# Project Initiation Notification System (PINS)

**Modify Section 5.3.4.4 as shown below. A new Figure 5-7 has been added, existing figures should be renumbered accordingly.**

**FIGURE 5-7 Vertical air temperature gradient limit as a function of whole body thermal sensation.**

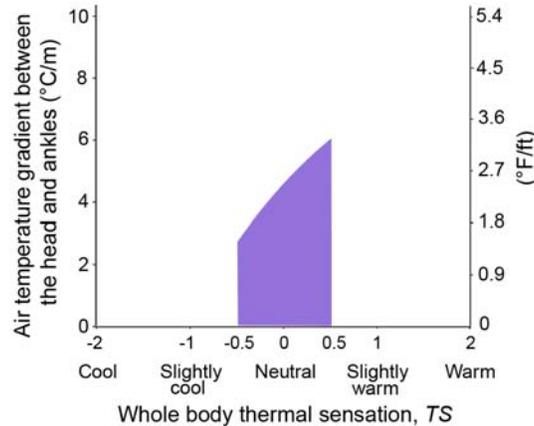
**5.3.3.4 Vertical Air Temperature ~~Difference-Gradient~~.** Air temperature ~~difference~~ gradient between head level and ankle level shall not exceed the value resulting from the following formula or in the shaded region of Figure 5-7 3°C (5.4°F) for seated occupants or 4°C (7.2°F) for standing occupants. (see note in Section 5.3.4.1).

**FIGURE I-4 Vertical air temperature gradient limit between the head and ankles as a function of whole body thermal sensation and the predicted percentage dissatisfied with vertical air temperature gradient ( $PPD_{vT}$ ).**

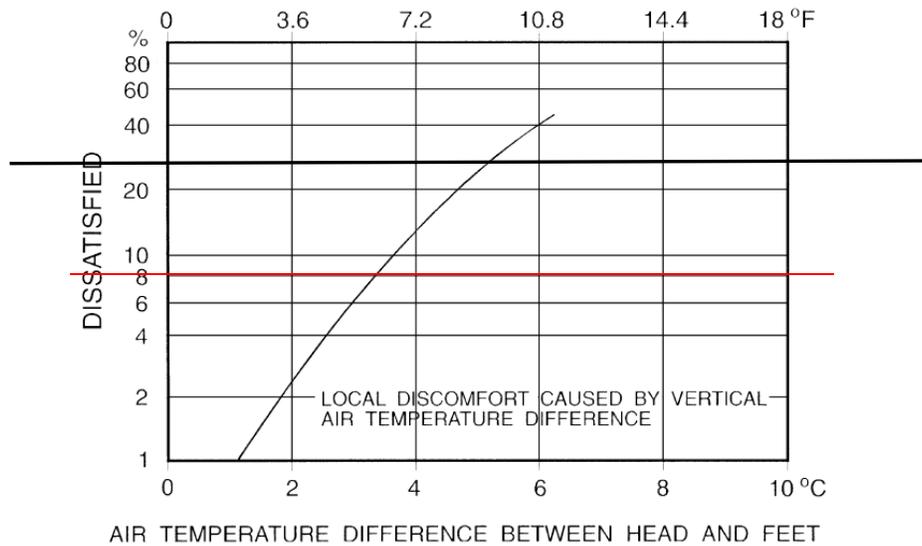
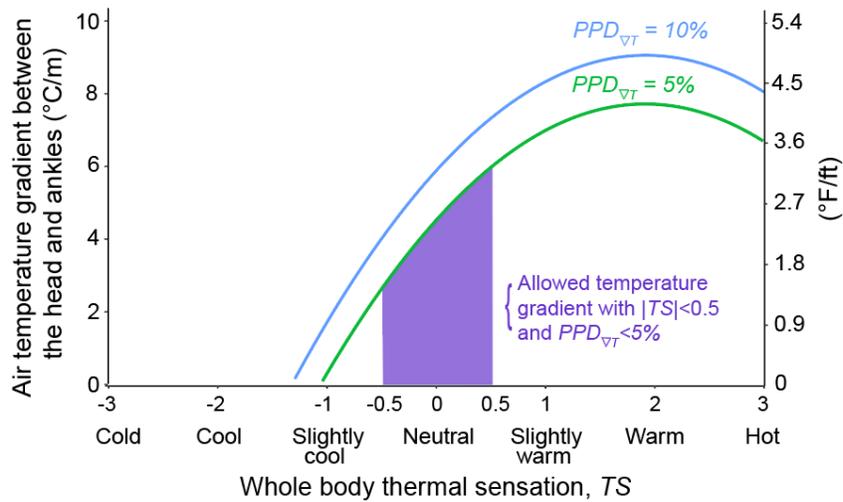
Figure I-4 shows the expected percentage of occupants who are dissatisfied due to the air temperature difference where the head level is warmer than the ankle level. Thermal stratification in the opposite direction is rare, is perceived more favorably by occupants, and is not addressed in this standard.

The allowable difference in air temperature from ankle level to head level is based on Figure I-4 and assumes that a maximum of 5% of occupants are dissatisfied by the vertical air stratification.
